Memorandum

Date: June 17, 2008
To: Brent Kellet
From: C.C. Macey, P. Eng.
Subject: Bishop Grandin Greenway Asphalt Path – Glen Meadow Street to River Road
Project Number: 0265-389-00 (4)

Figure 1: Cubic Parabola Design Curves – FGSV AWWA C301 24” (600mm) Approx. Class 15 Pipe

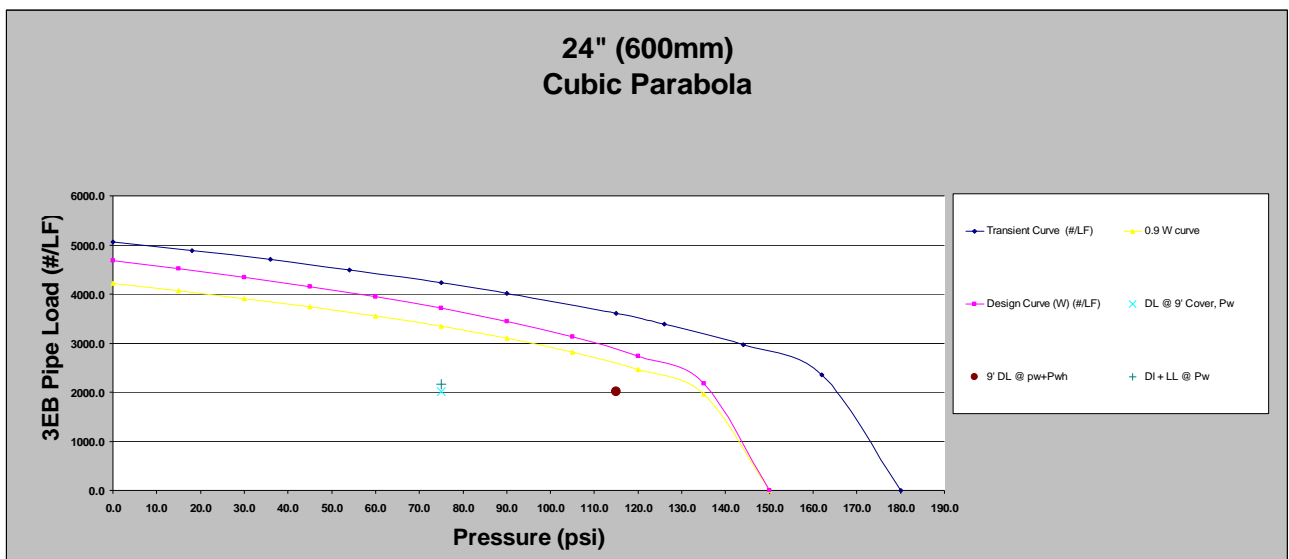
We have analyzed this section of the 600mm FGSV Feedermain using the same assumptions stated in the 2007 report as the pipes were installed under the same contract and are the same class of pipe. The cubic parabola design curves and points associated with the applied loadings at 2.74 m (9 feet of cover) are presented in Figure 1 below.

The figure illustrates that all of the final control design points are all within the allowable limits of the pipe.

Figure 2: Applied Loads vs. Height of Cover

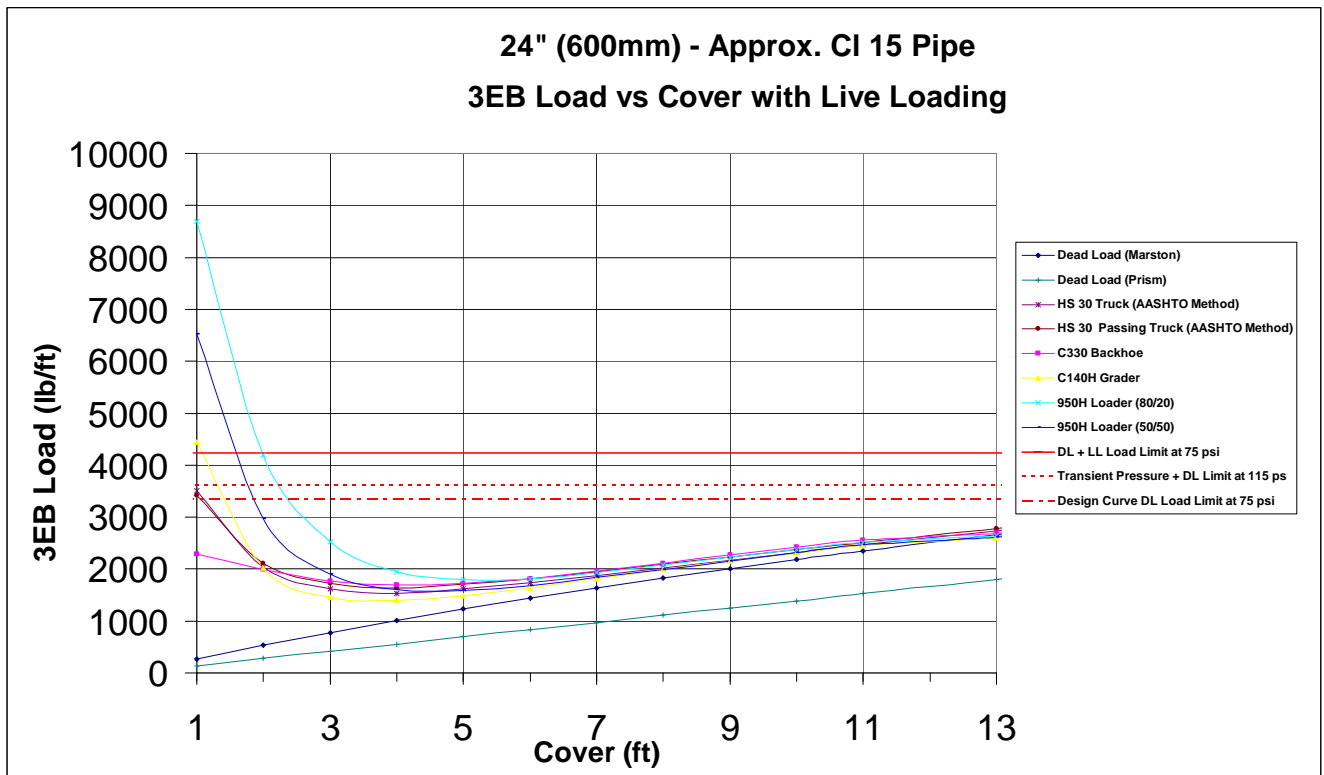
We also reviewed various applied live loads at a range of heights of cover. The results are plotted in Figure 2 below versus the limit states for the pipe with applied loads ranging from the dead load at normal operating internal pressure, the dead + live load at normal operating internal pressure, and the dead load at normal operating internal pressure plus internal transient event pressure. As evident below, while there is a great deal of apparent structural capacity of the pipe we are assuming the pipe to be in good physical condition and the applied loads increase dramatically at heights of cover of less than 3 feet.

Based on other excavations of this particular pipe, it is a reasonable assumption to assume it is still in good physical condition, although it is still prudent to proceed working over it with an abundance of caution. The increase in applied loads at very low heights is the primary reason that we are very concerned about potential rutting in instances where exposed subgrade gets wet or if temporary crossings are not maintained on a regular basis.
